## Land Use Application Updates (per 2/28/23 email)

LAND USE APPLICATION  
3/10/2023

3 ZONE C PERENNIALS AND SHRUBS  
1" = 20'-0"

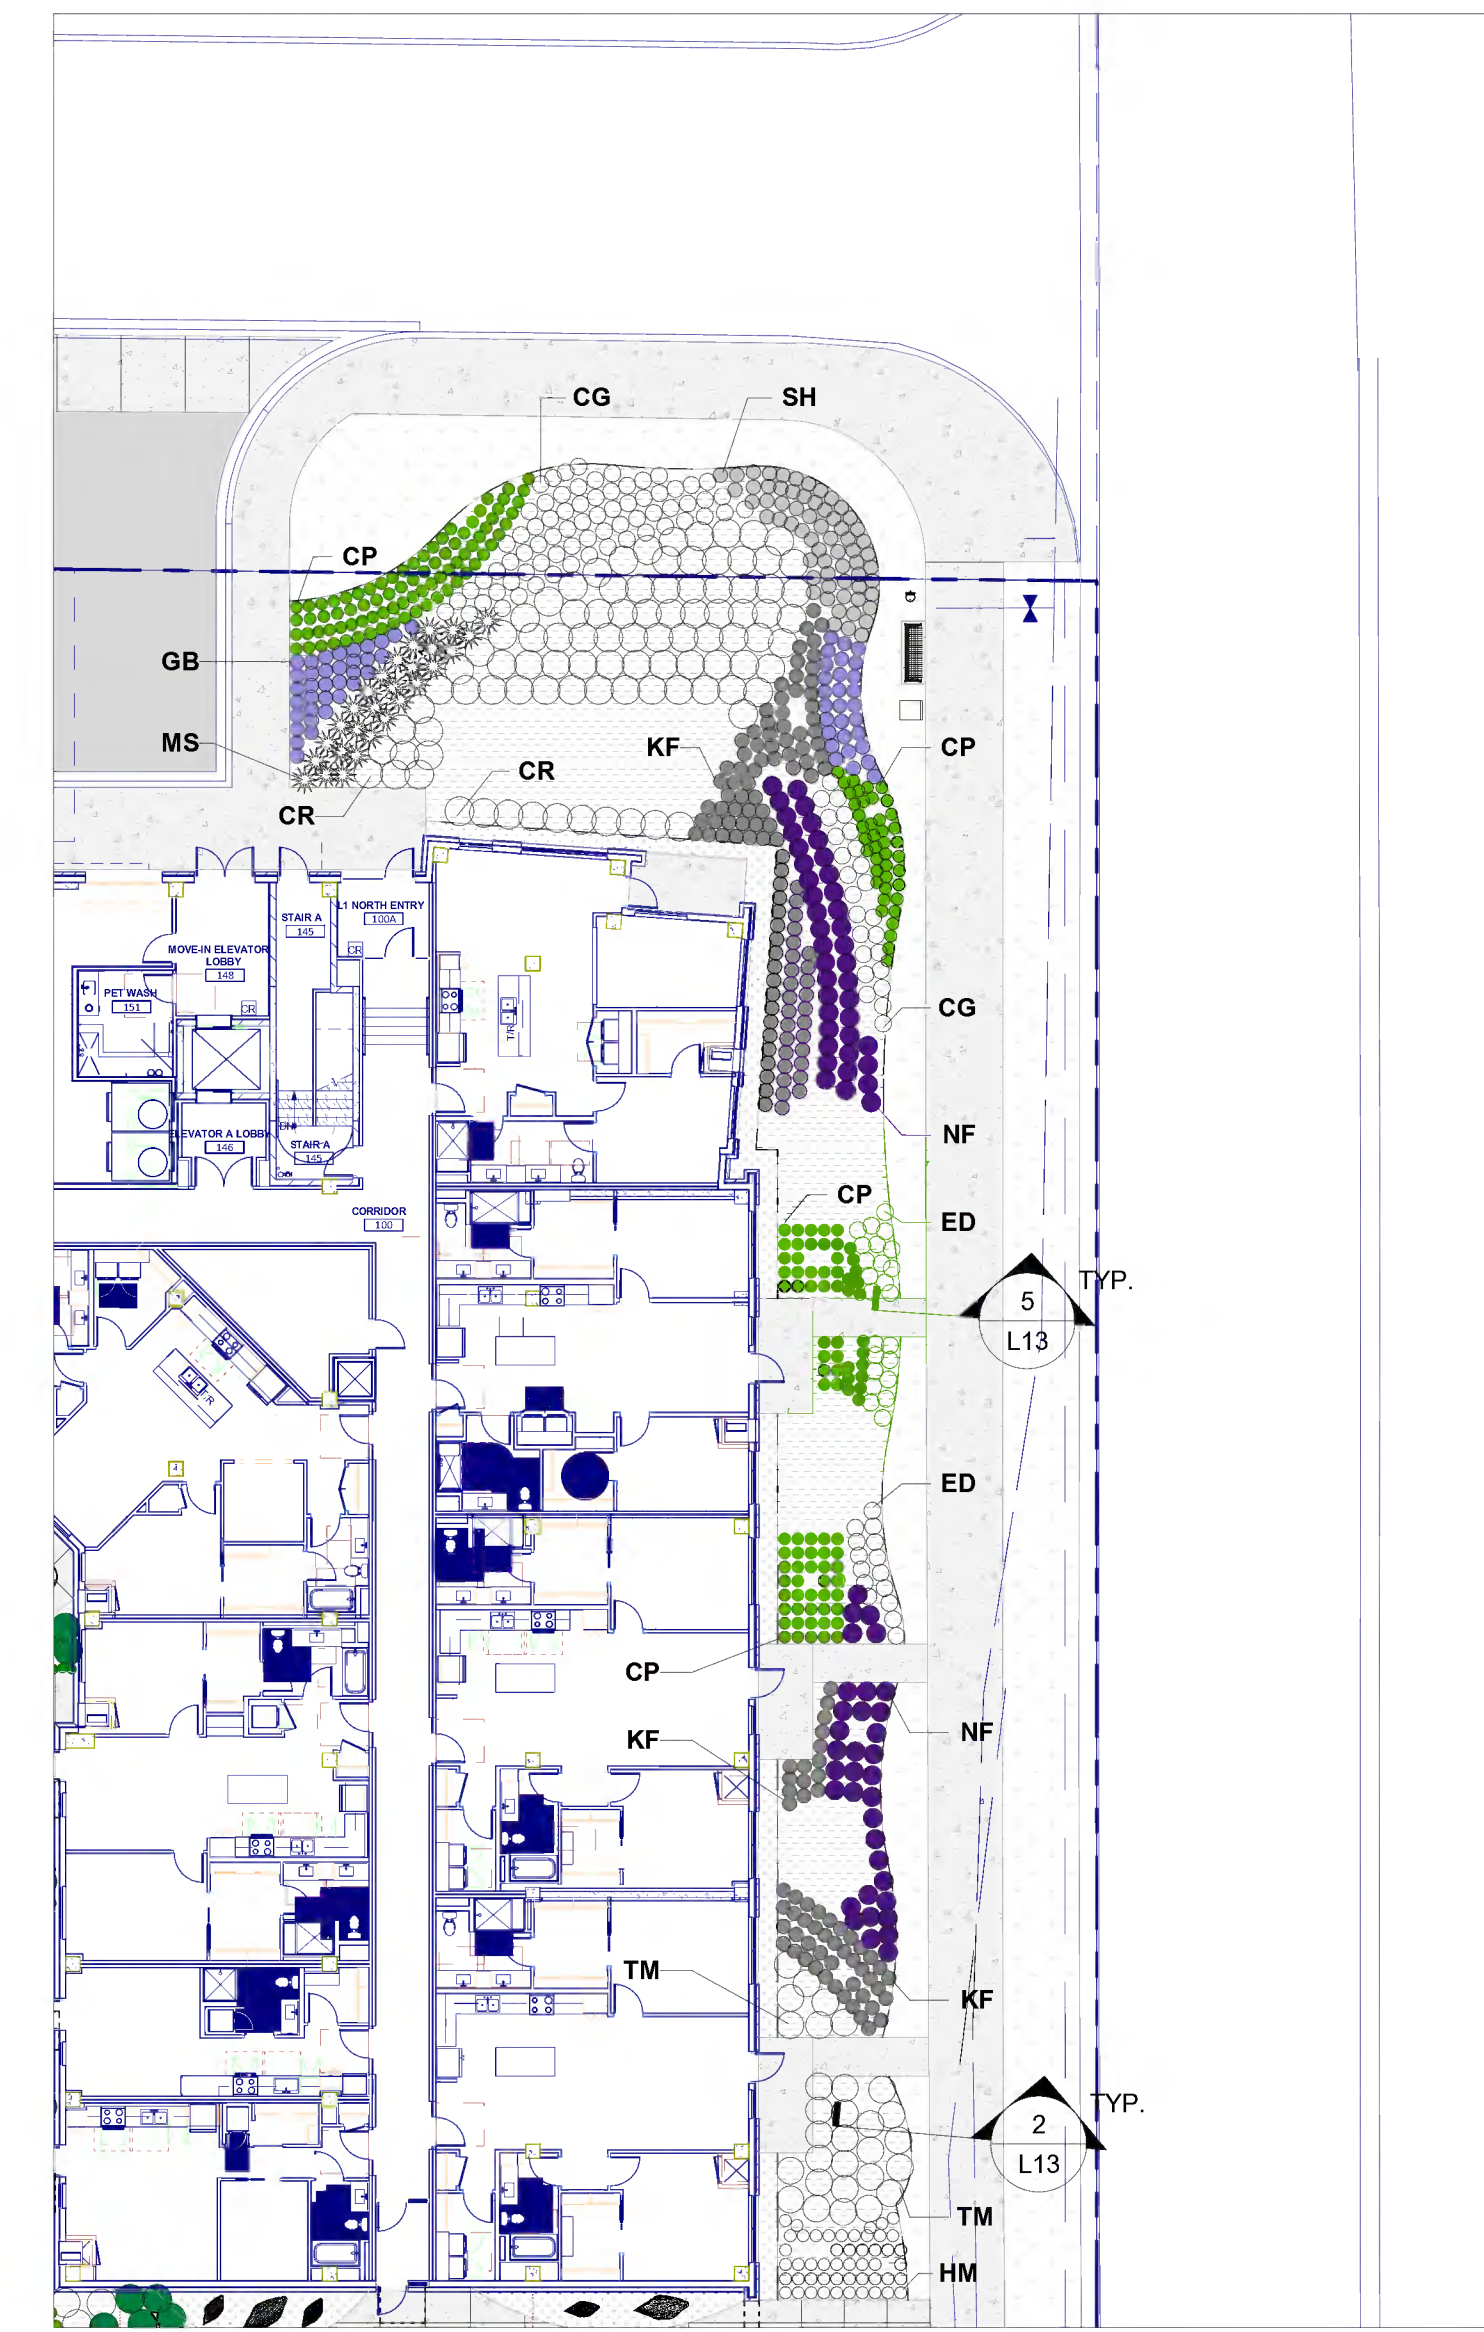
The plan must also incorporate pedestrian furniture, wayfinding signage from the Opus placemaking guide and dog waste bags. See top exhibit of L3 sheet, left exhibit of L4 sheet, and left exhibit of L5 sheet.

IRRIGATION SCHEDULE

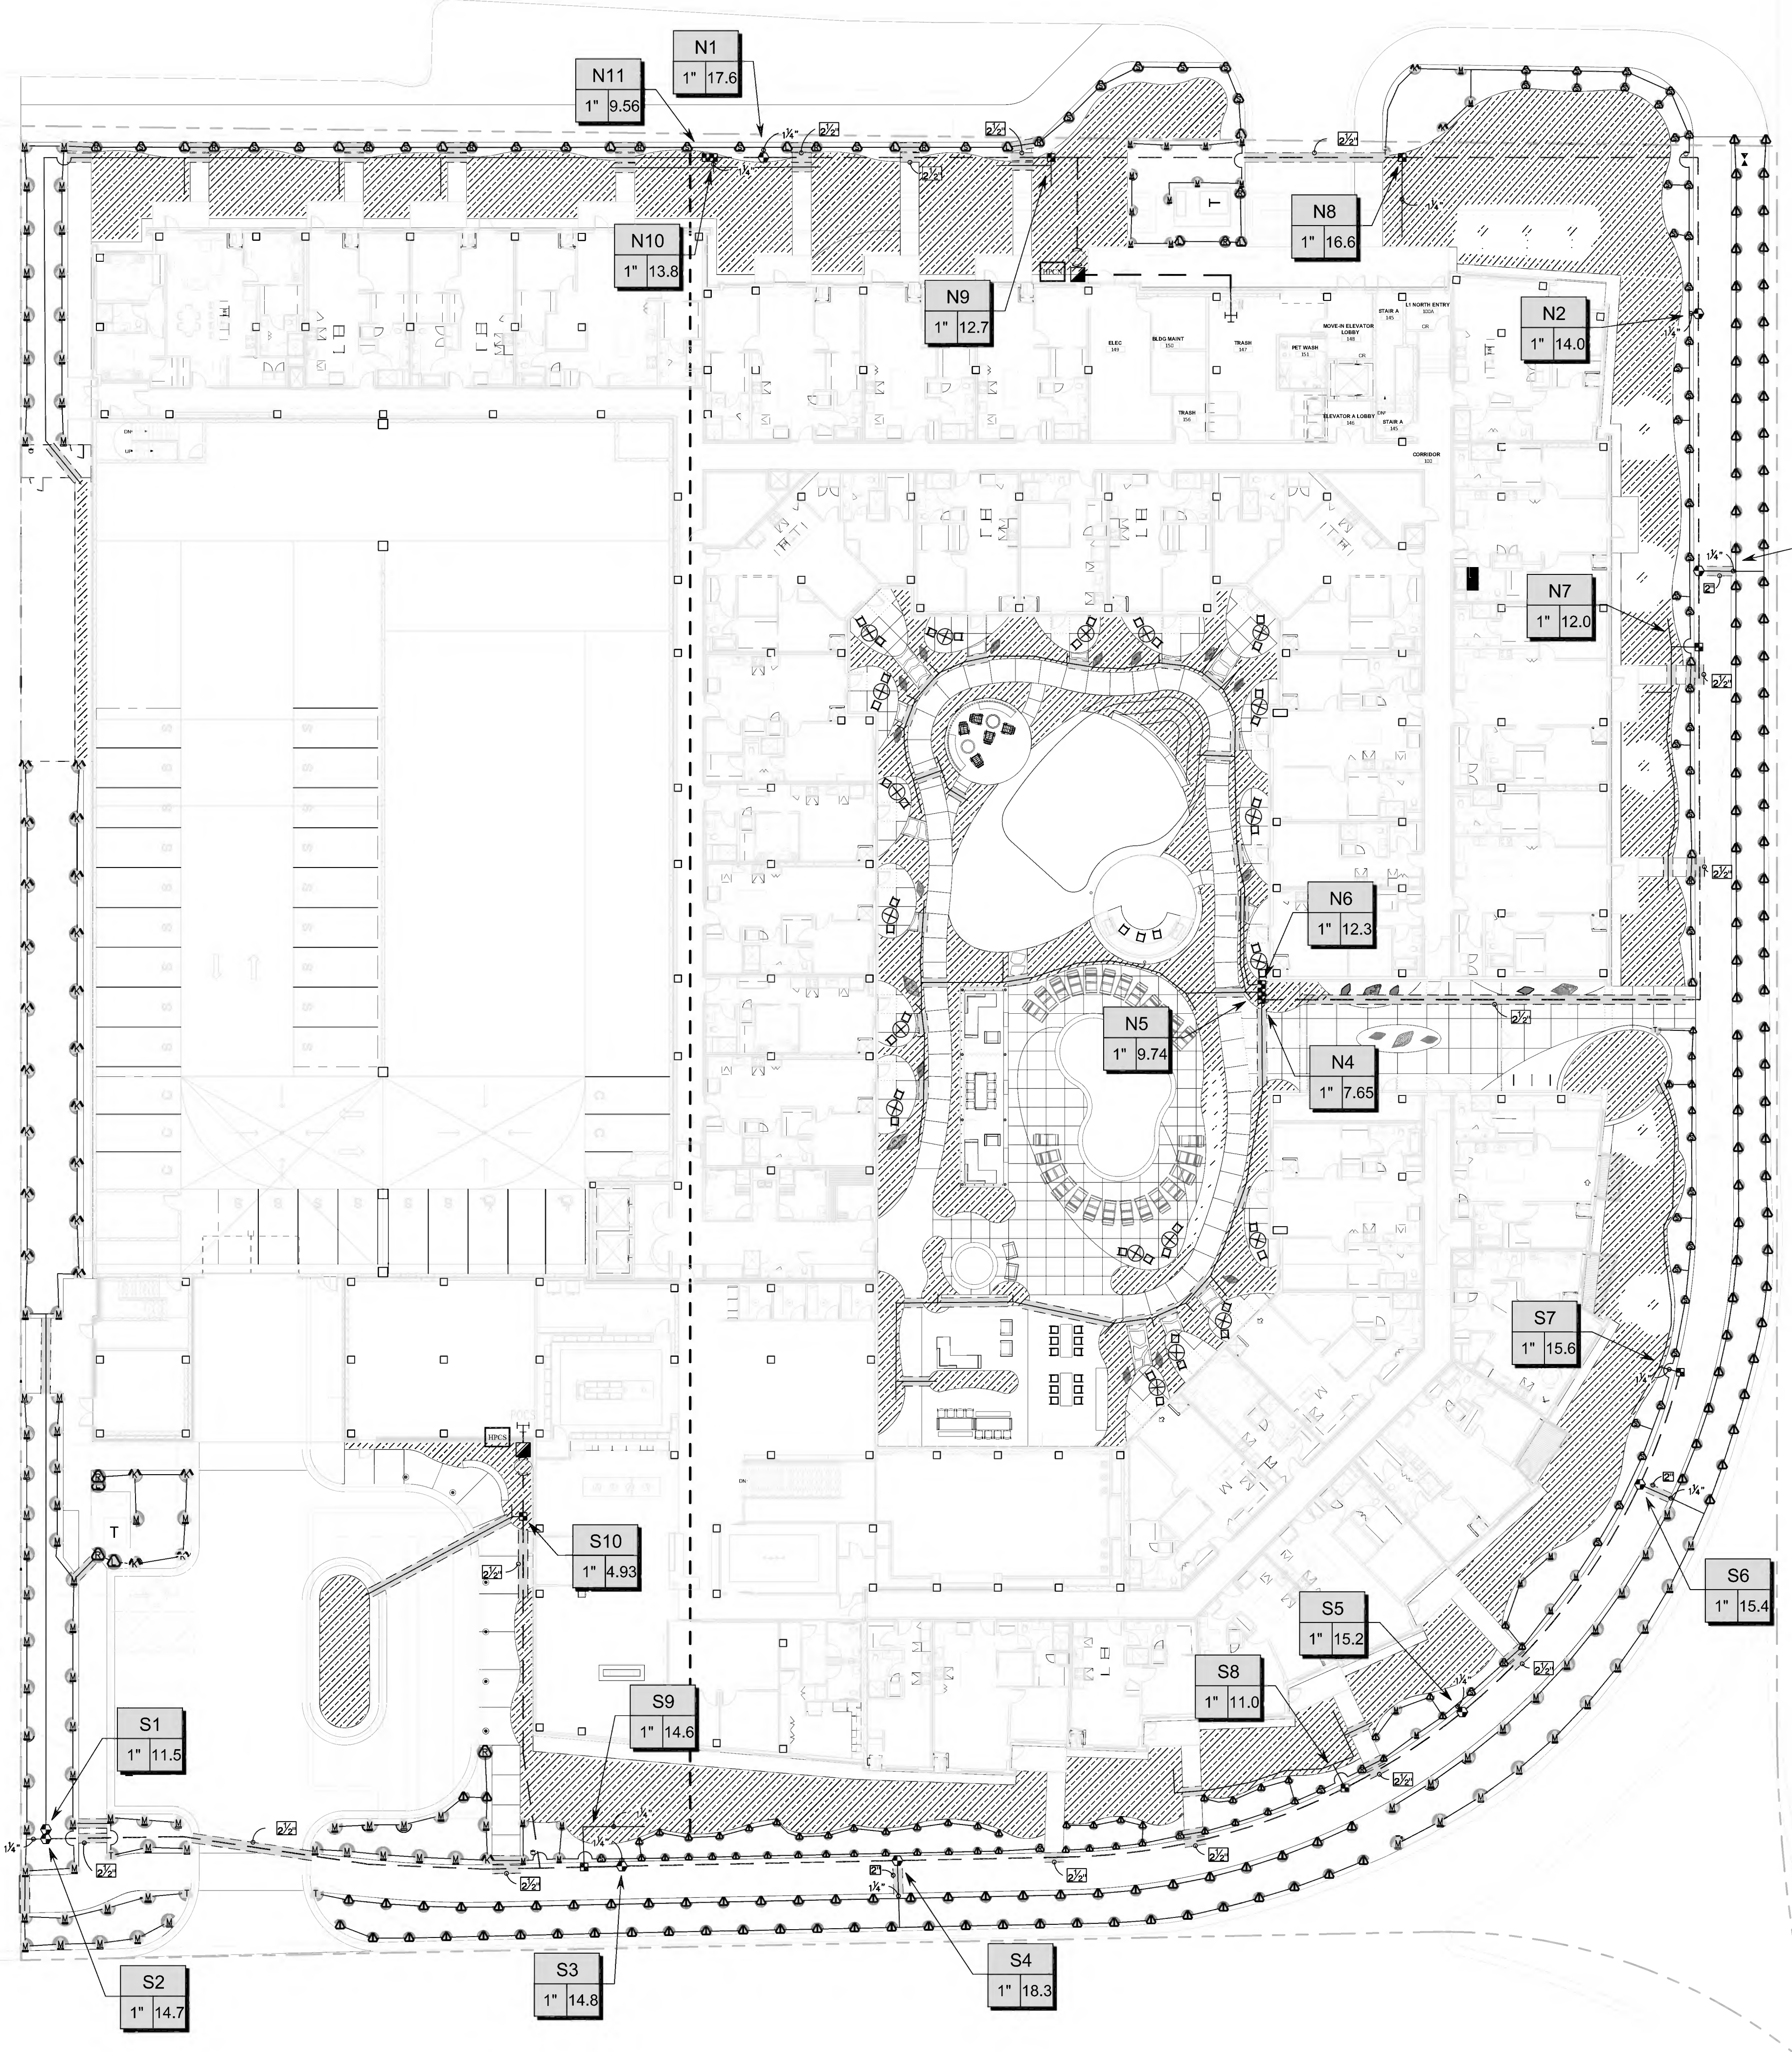
- Stormwater plan:** An irrigation plan is required as water reuse is being used to meet stormwater rules. This irrigation plan should be complemented by the landscaping plan (see more below). No credit is given to the area on the adjacent property or areas incorporating artificial turf. **Understood.** Additionally, all support systems (reuse pump and generator) must be shown on all plans, including the landscaping plan. **Greystar has officially engaged a stormwater reuse engineer, Rainwater Management Solutions out of Roanoke VA, and an irrigation design specialist Aqua Engineering Inc out of Eden Prairie, MN, to design this system. This system is in the initial schematic design phase and is further developing this system for the project.**

The stormwater harvesting system is indicated on plan sheet C6.01 at SW corner and NE corner. Also indicated on plan sheet IR100 Irrigation Design: POCS and POCN, HPCS and HPCN. Sheet A1.0 shows the south and north system locations in the building. Corner of bike room in the SW, and in the corner of the trash room at the NW.
